ADA Curb Ramp New Construction Inspection Form (Perpendicular)

24952.54

Timeric

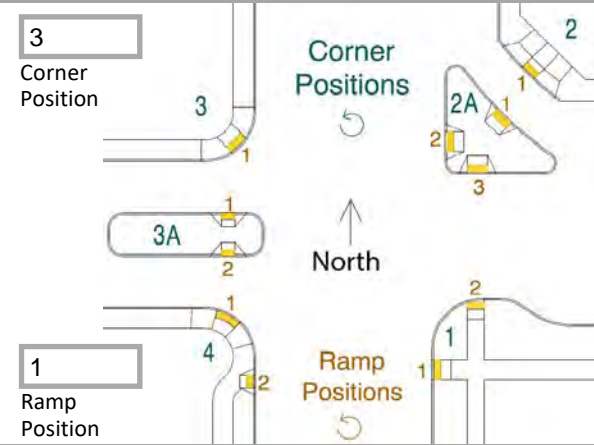
CS FAIL NORTH END
